RE: John Street Pond Feasibility Design Analysis Report
Engineer's Stamp Date: 11/09/23
Hydrology File: L14D067

COMMENT RESPONSE LETTER

RE: John Street Pond Feasibility Design Analysis Report
Engineer's Stamp Date: No date
Hydrology File: L14D067

JOHN STREET POND FEASIBILITY DESIGN ANALYSIS REPORT

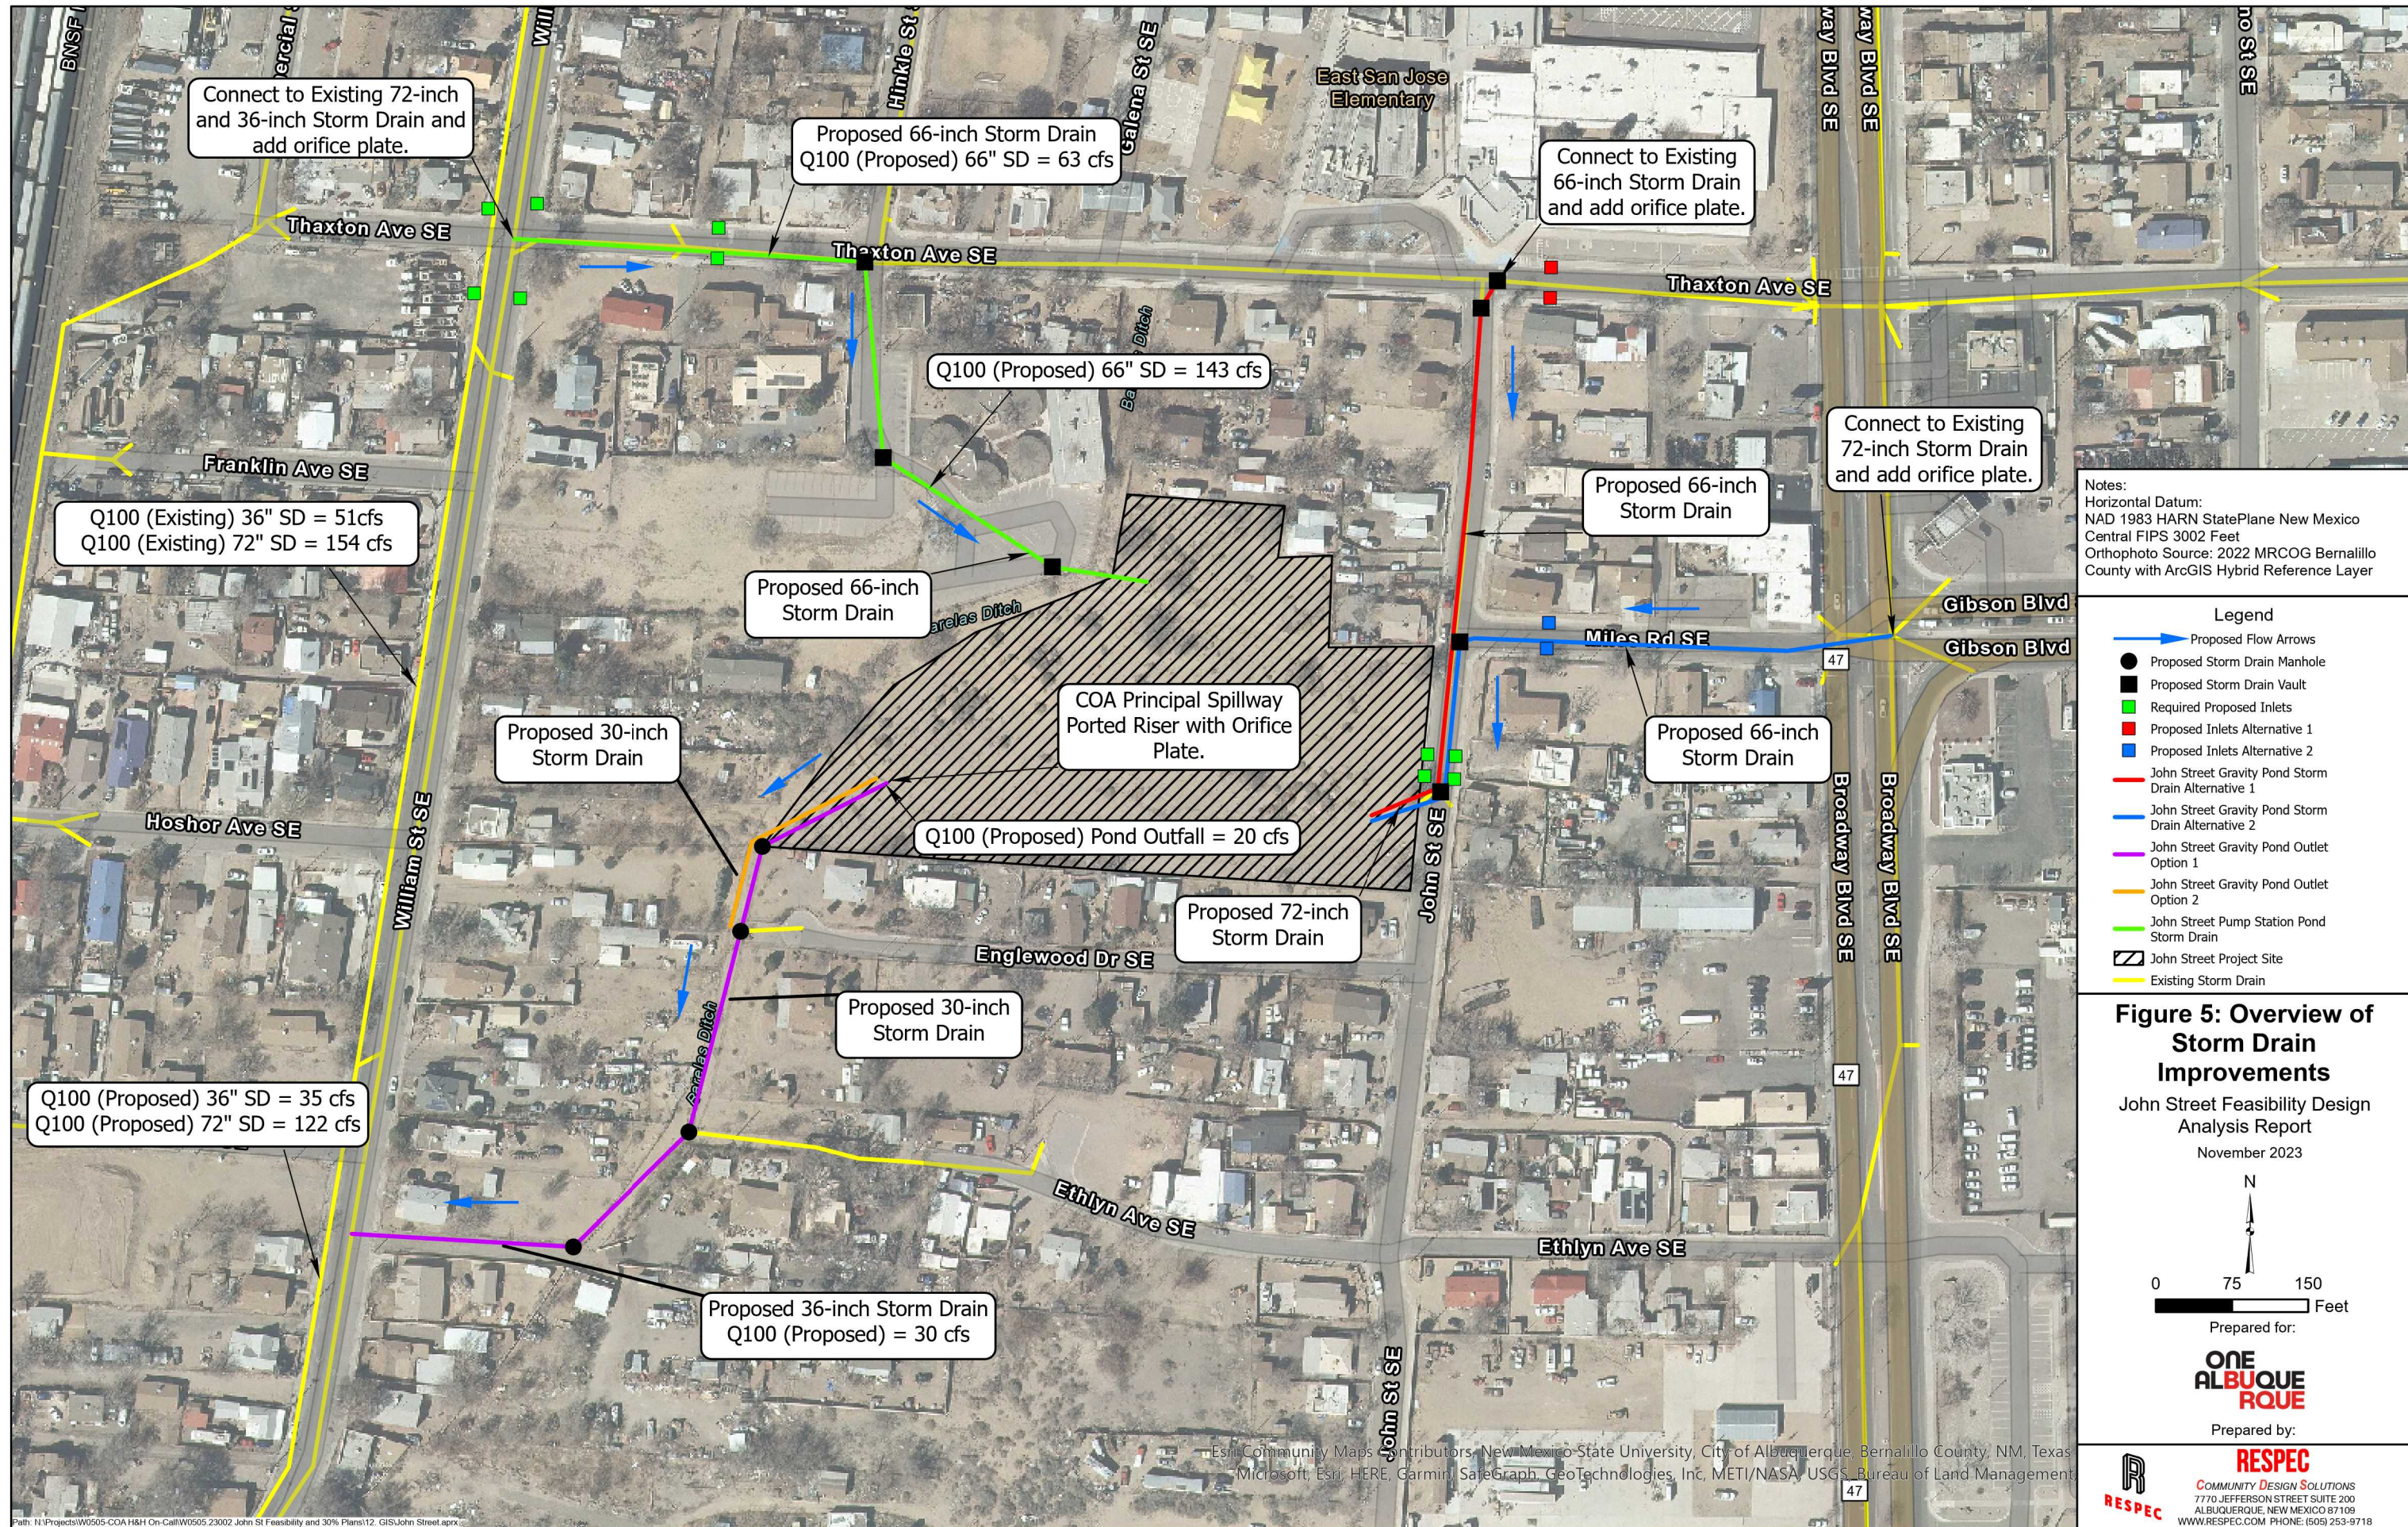
5. Figure 4, Overview of Storm Drain Improvements. It would be very helpful if you include the Q100 at the storm pipe for both the existing and the proposed on the map. (See below) This should be help explain how the whole proposed system will help with the capacity in the existing storm drain by the proposed detention & pump station.

[These were added to the figure.](#)
